**METAL BANK SUPERFUND SITE
PHILADELPHIA, PENNSYLVANIA**

RECORD OF DECISION

**PREPARED BY
THE ENVIRONMENTAL PROTECTION AGENCY**

DECEMBER 1997

Figure 3
Site Plan
Metal Bank Site

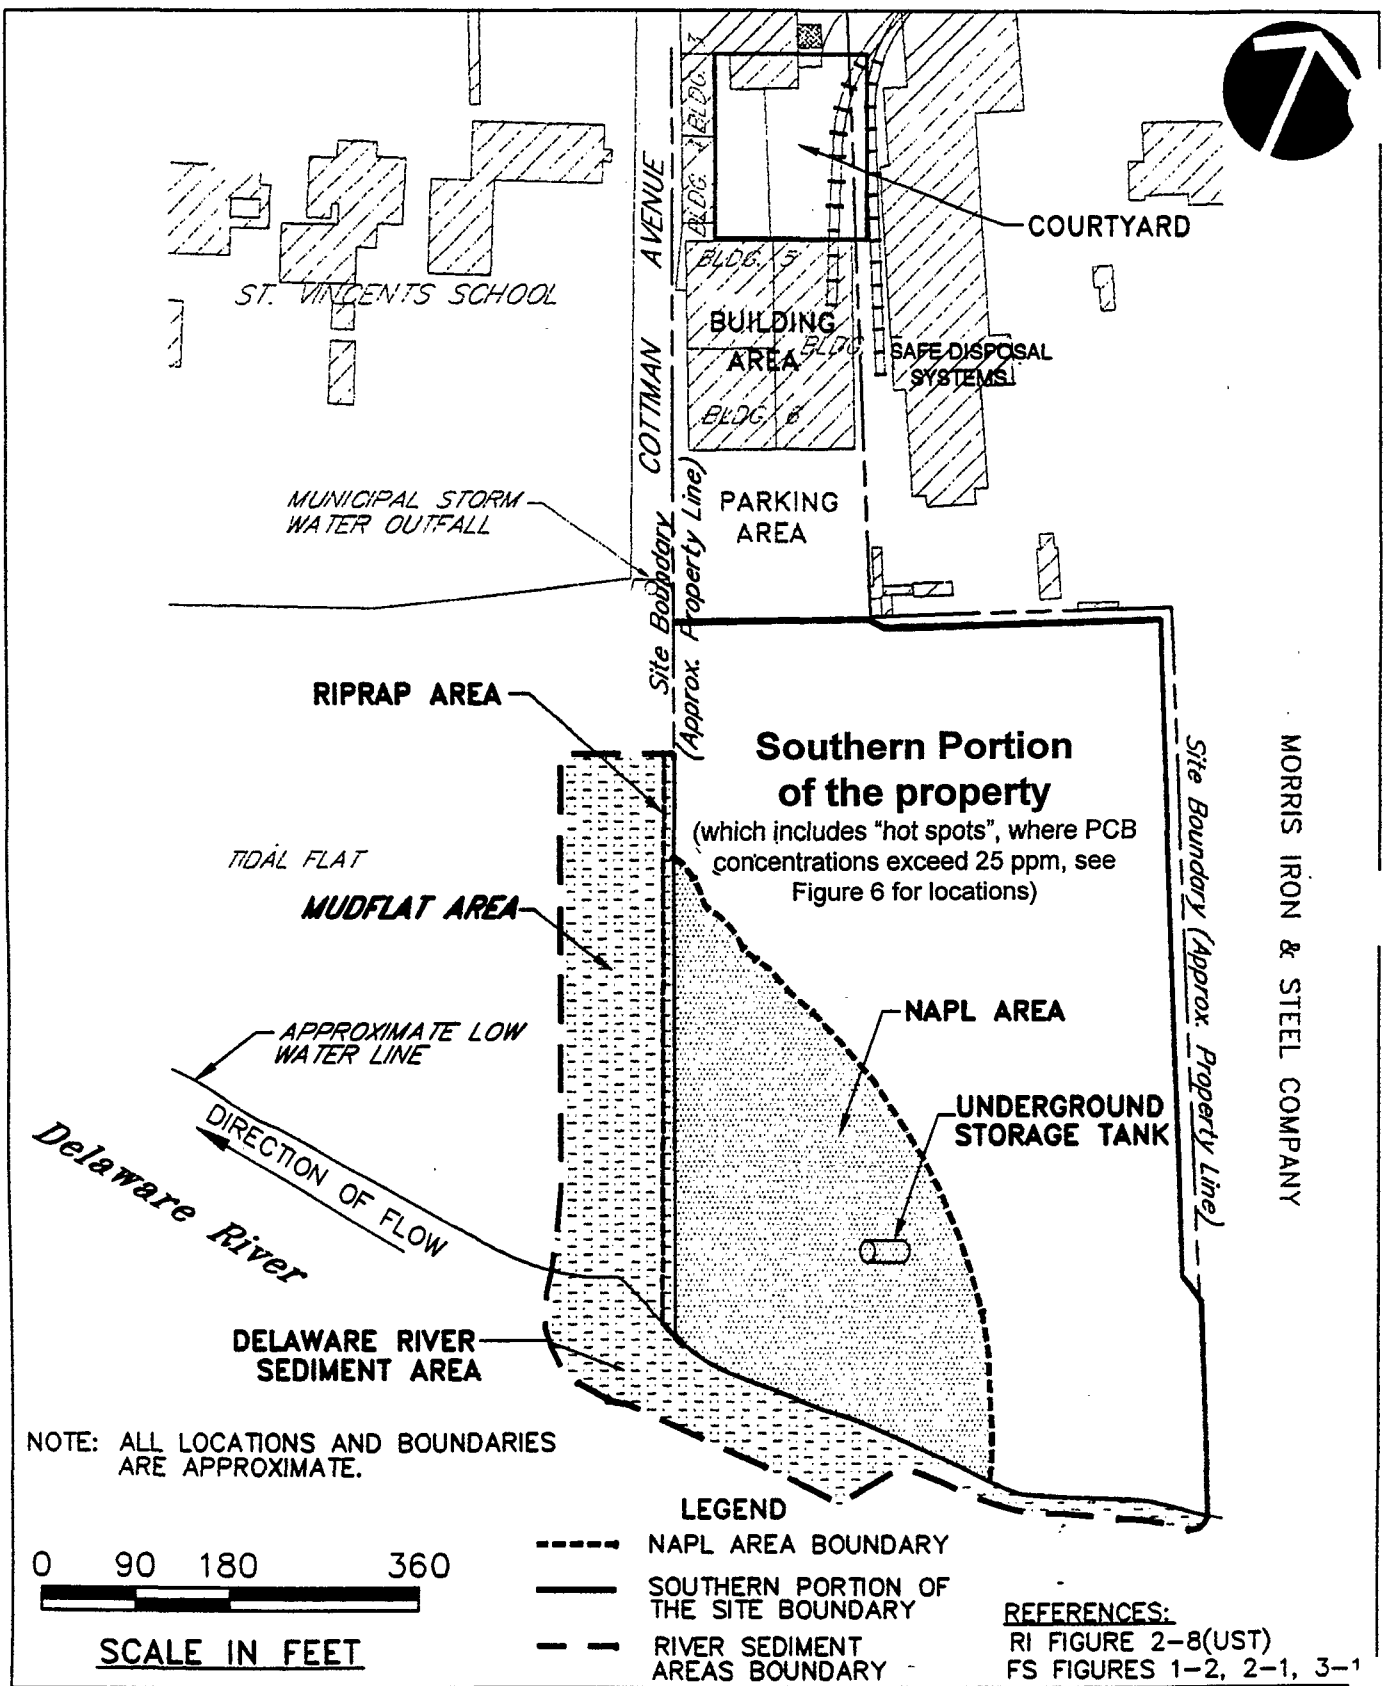
Finally, the lateral extent of contamination along the shoreline, including the areas near the City's storm water outfall and Morris Iron & Steel (*see* ROD Figure 3, near the northwest and southeast corner of the Southern Portion of the property), has not been defined. This, combined with the possibility that it may not be feasible to excavate sediments in the river beyond 100 feet of the shoreline, has prompted EPA to require additional sampling during the Remedial Design. Since the PRPs did not provide documentation during the RI/FS to substantiate their concerns regarding excavation difficulties, additional engineering measurements (*i.e.*, soil and river current data) will also be required as part of the Remedial Design to determine where the final placement of the temporary wall should be.
